Service
Note

N0203022

Subject: Steering Dampeners - Part Number 539102720

Effected Model Numbers: All Commercial Turf Care Mini and Large ZTH Riders (excluding the Gen One)

**Upper Dampener
Attaching Points
(White Arrows)**

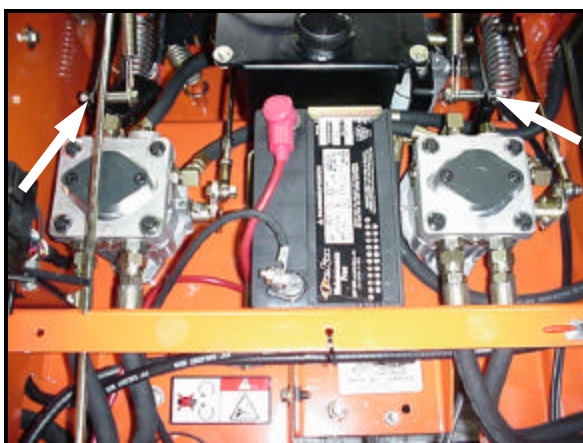
It has been determined that the locknut on the bolts that retain the steering dampeners may be too tight. This places the dampener clevis in a bind, side loading the dampener. This side load may cause premature failure of the dampener seals.

There must be 1/8" to 3/16" clearance at the dampener clevises, both on the upper and lower mount. Additionally, there must be no interference between the dampener shaft or body and any part of the frame or other fixed object.
